Reference: **TB 0202 (04/2026)**

Technical Bulletin

Product: HWDU-151 4,5kW 1N (7748000736)

Change of 3 way valve manufacturer

Fig 1.

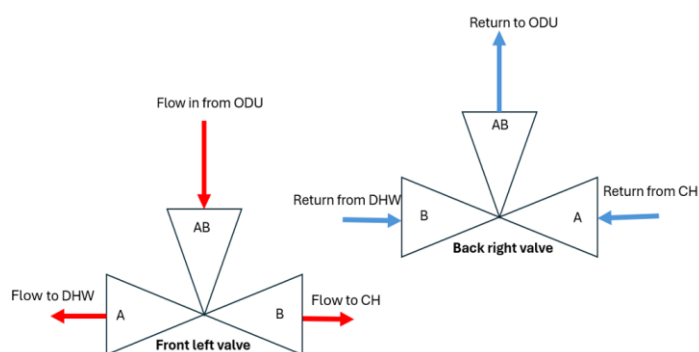
When replacement 3 way valves are required on a HWDU-151 4,5kW 1N (7748000736), we have to replace the existing valve with part number **8733701136** (compression) or **8733701138** (flat face with washer) depending on the variant used on the existing unit.

The new valves will be fitted in the orientation shown in figure 1:

Fig 2.

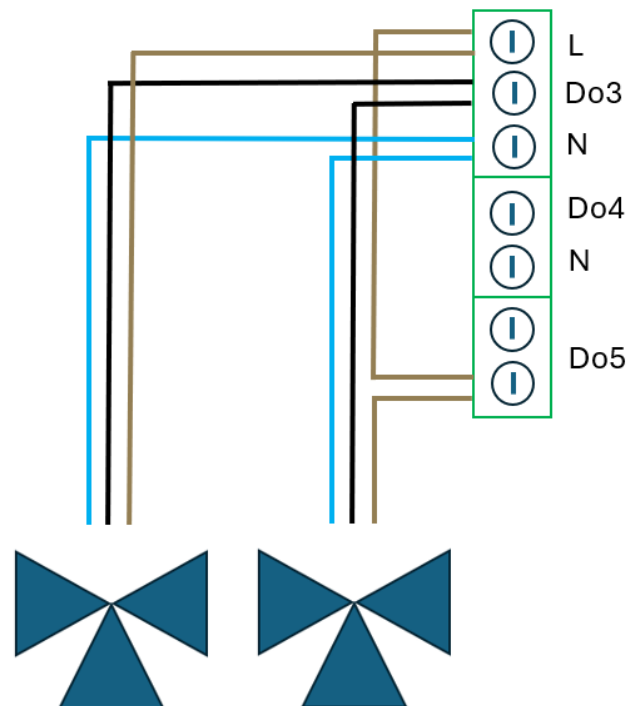
A new wiring harness will be required for each valve. Part number: **87183103970**.

The previous wiring colours have changed, please see below.

Brown wire will now be black.

Black wire will now be brown.

Blue – Blue.

Wire the cables as follows in figure 2:
